CFM in Backbone Edge Bridges

Norman Finn

P802.1ag/D7.1 Figure 22-1

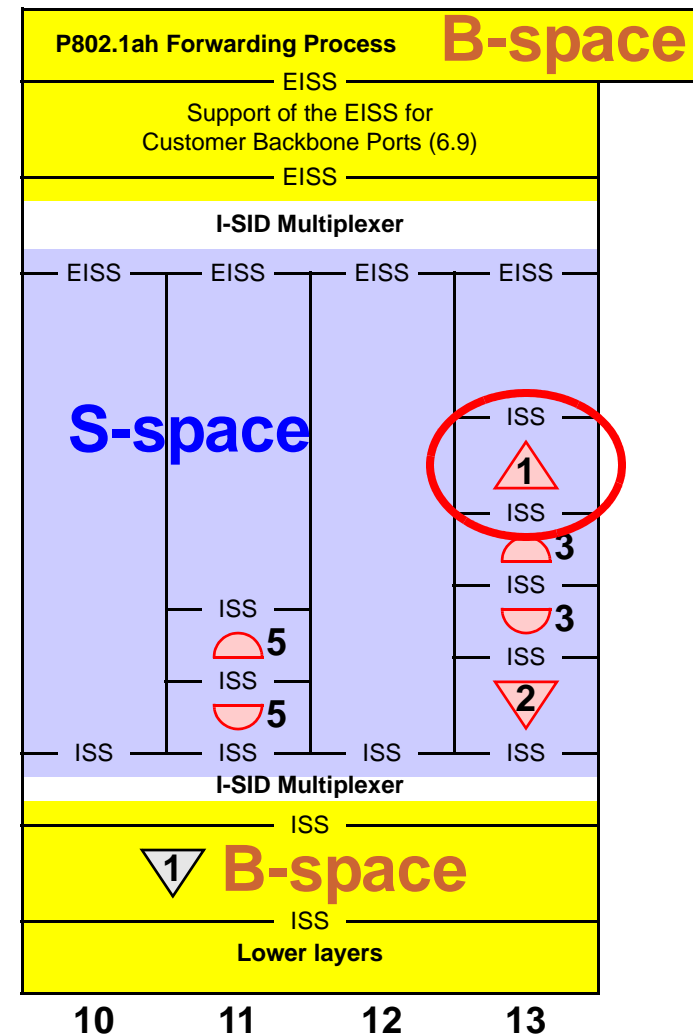
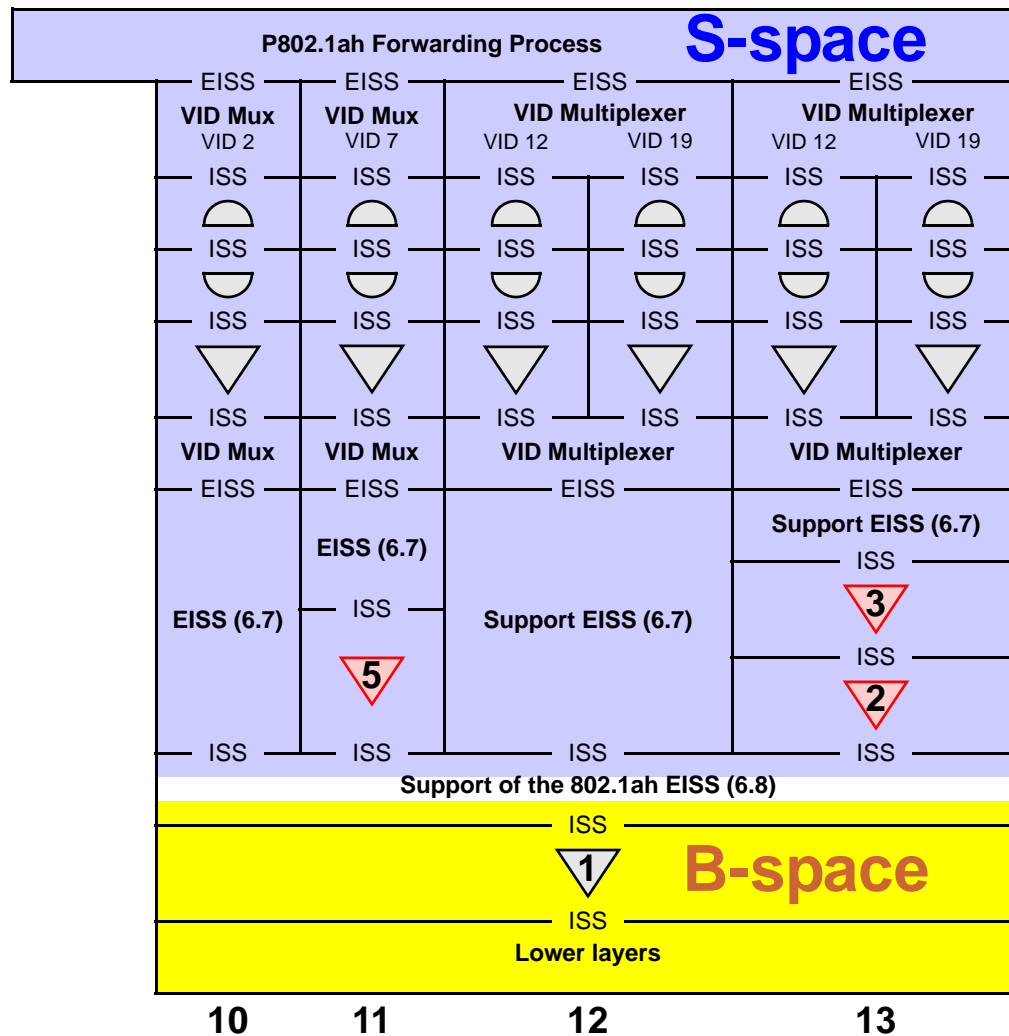
But, what B-destination does the MEP at level 1 use for an LBM?

- **Error:** Every S-B or B-S transition requires an I-component's learning element.

I-Component with Connection MEPs

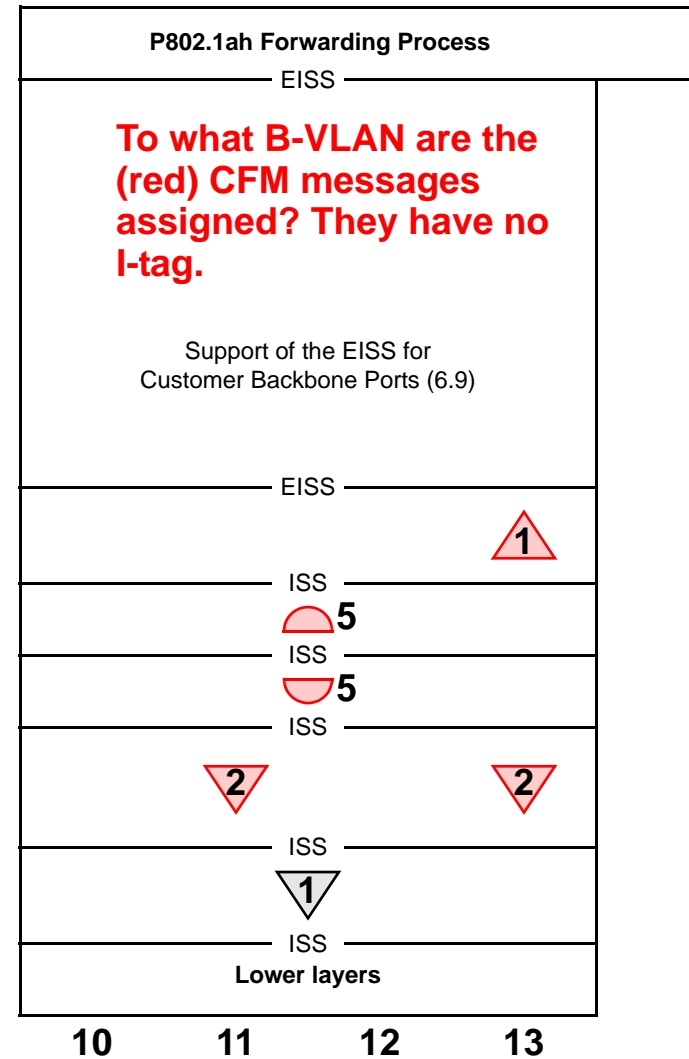
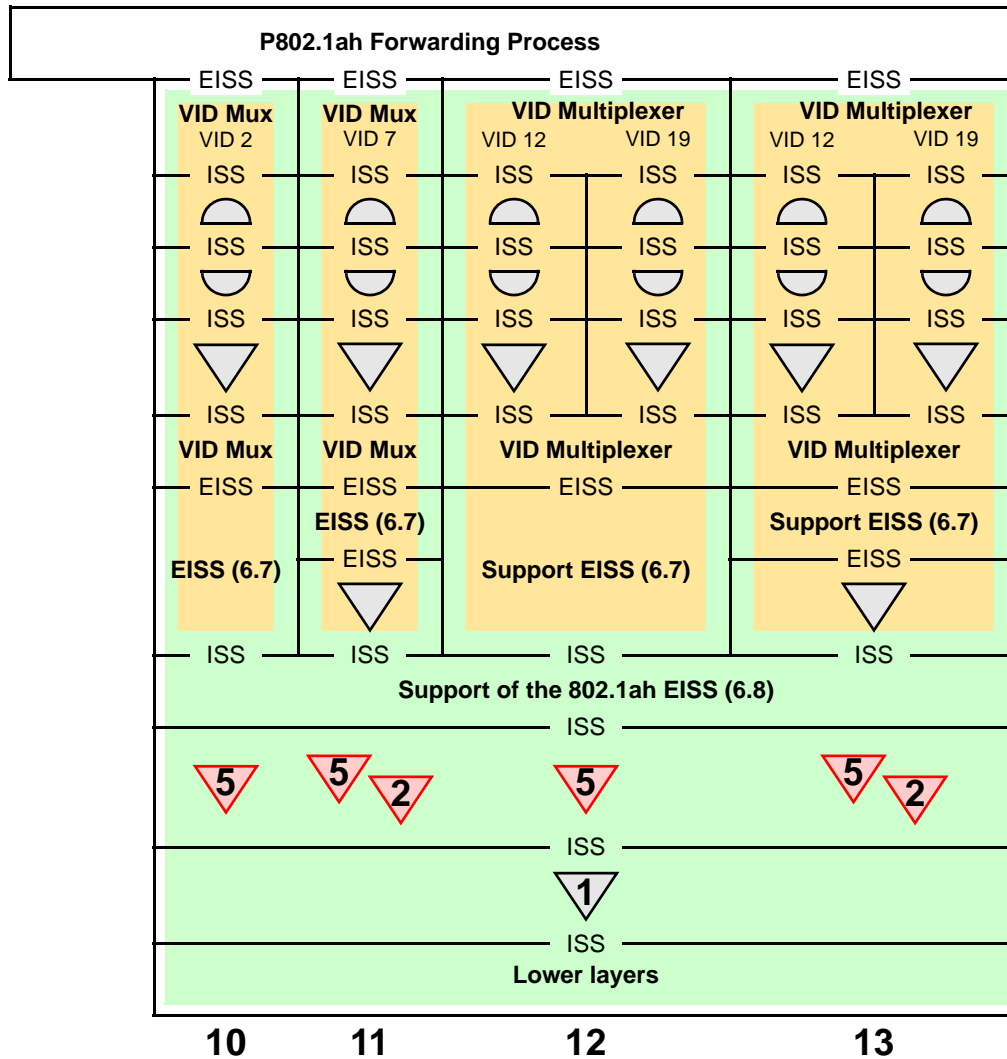
- **Connection MEPs cannot pass an I-tagged NNI.**

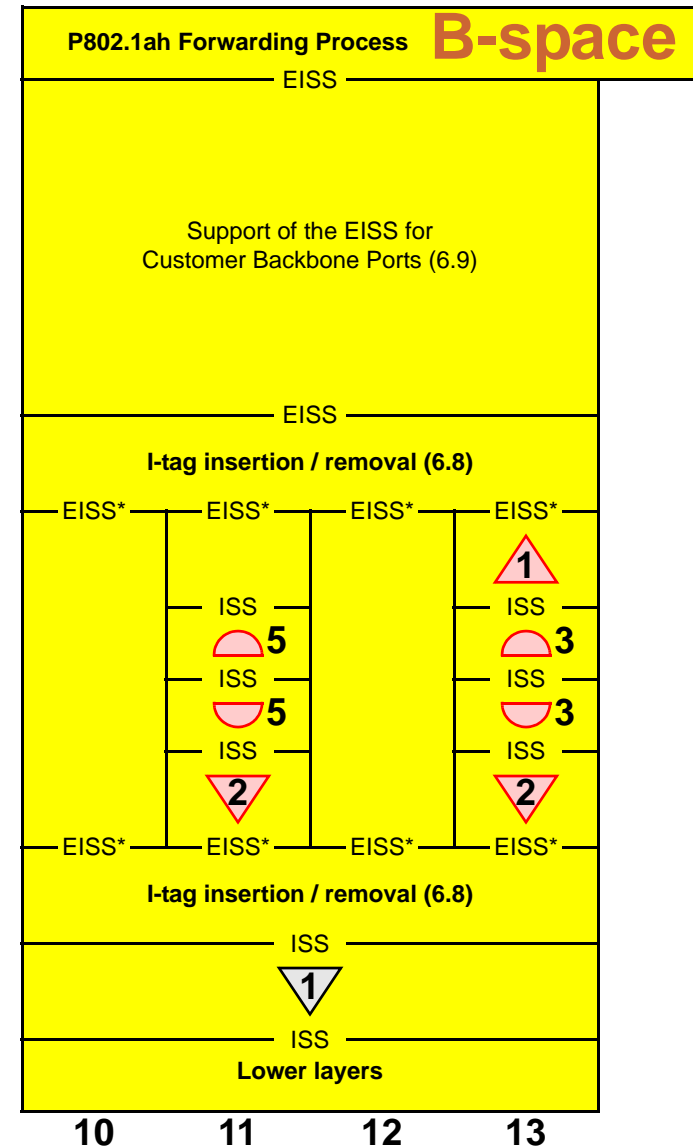
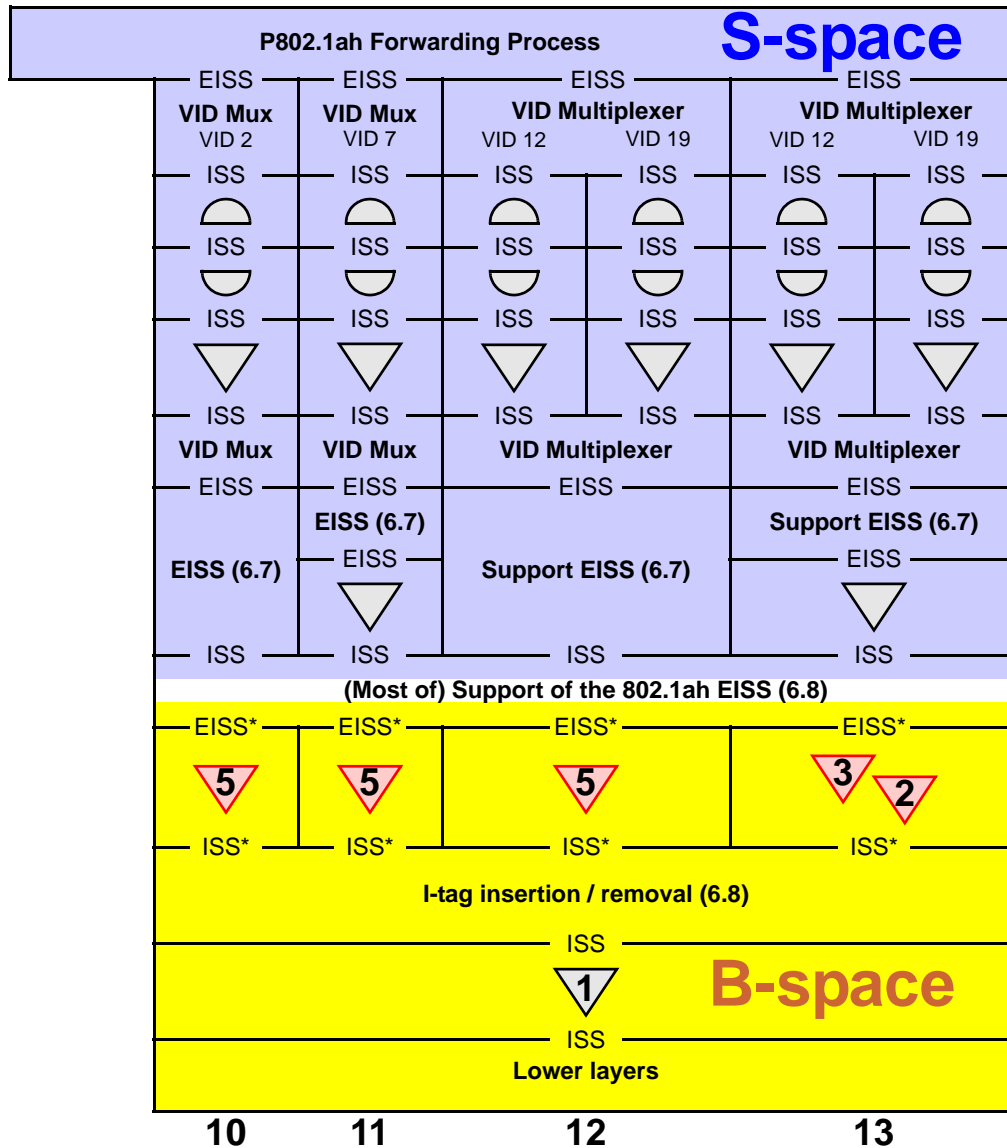
I-Component with per I-SID MEPs seems to work.

* These interfaces are probably not really EISS and ISS interfaces; more work needed, here.
